APPLICATION NO.	FILING DATE	FIRST NAMED INVENTOR	ATTORNEY DOCKET NO.	CONFIRMATION NO.
10/623,768	07/21/2003	Koji Sakai	4041K-000140	4834
27572	7590	10/29/2004	EXAMINER	
HARNESS, DICKEY & PIERCE, P.L.C. P.O. BOX 828 BLOOMFIELD HILLS, MI 48303			JIMENEZ, MARC QUEMUEL	
		ART UNIT		PAPER NUMBER
		3726		
DATE MAILED: 10/29/2004

Office Action Summary	Application No.	Applicant(s)
	10/623,768	SAKAI ET AL. <i>Ch</i>
	Examiner	Art Unit
	Marc Jimenez	3726

DETAILED ACTION

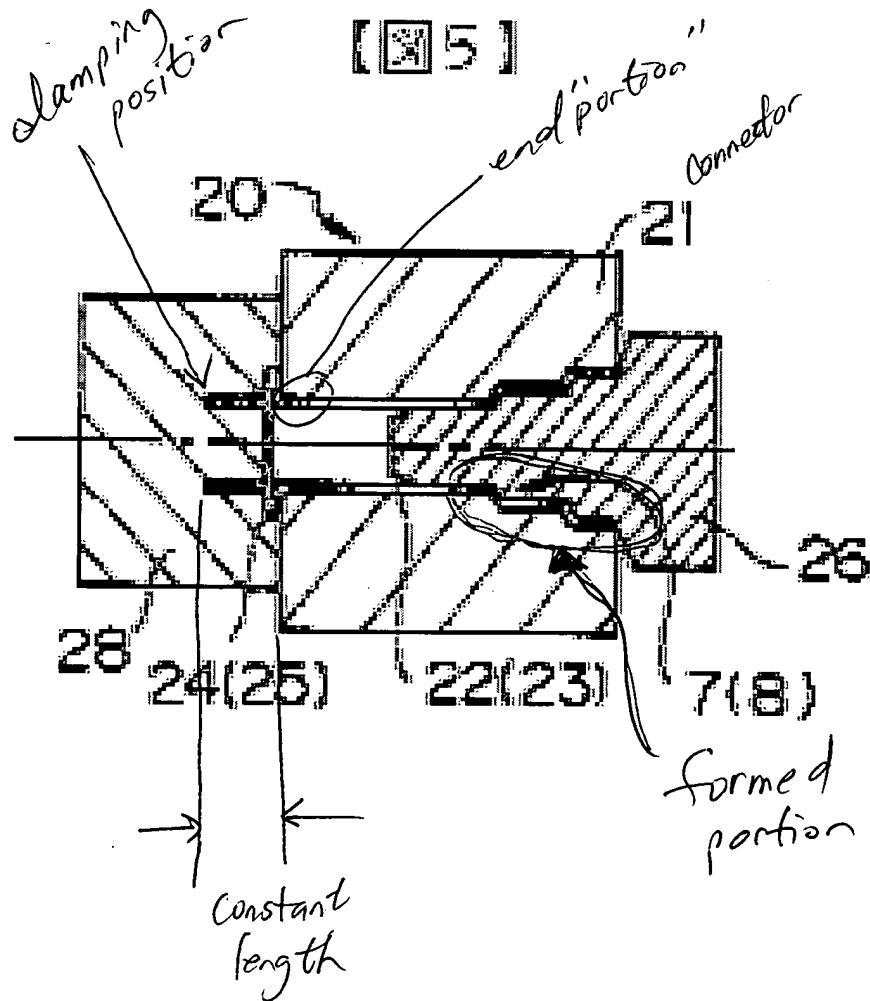
Seiji teaches a method of manufacturing piping 22 having a joining portion, the piping 22 having a connector 21 at an end portion, comprising the steps of: clamping and fixing 28 a portion of the pipe 22 for adjusting a length of the pipe 22 simultaneously when the connector 22 is attached to the end portion; engaging the connector 21 having a through-hole with the end portion of the pipe; and forming 7 the end portion of the pipe 22 to the connector 21 so that the length from the clamping position 28 to the end portion of the pipe 22 can be constant, wherein the length of the pipe 22 is reduced when an excess material of the pipe 22 is absorbed by the formed portion (at 7) so as to adjust the length of the pipe 22 to a predetermined value. As shown in figure 4, the pipe extends beyond the right face of the connector 21. As the punch 27 is moved to the left in figure 4, the material of the pipe will be moved to the left and flush with the face of the right face of the connector 21 as shown in figure 7. As the material is deformed to the left and into the faces 7 of the connector, the material will be absorbed by the formed portion at 7.

8. Applicant argues that Seiji does not teach the concept of adjusting the pipe length. However, as shown in figure 4, the pipe extends beyond the right face of the connector 21. As the punch 27 is moved to the left in figure 4, the material of the pipe will be moved to the left and flush with the face of the right face of the connector 21 as shown in figure 7. As the material is deformed to the left and into the faces 7 of the connector, the material will be absorbed by the formed portion at 7. The teachings in Seiji is therefore considered to meet the claim limitations “.... clamping and fixing a portion of the pipe for adjusting a length of the pipe simultaneously when the connector is attached to the end portion, ...” as recited in claim 14. See mark up of Seiji fig. 5 below.
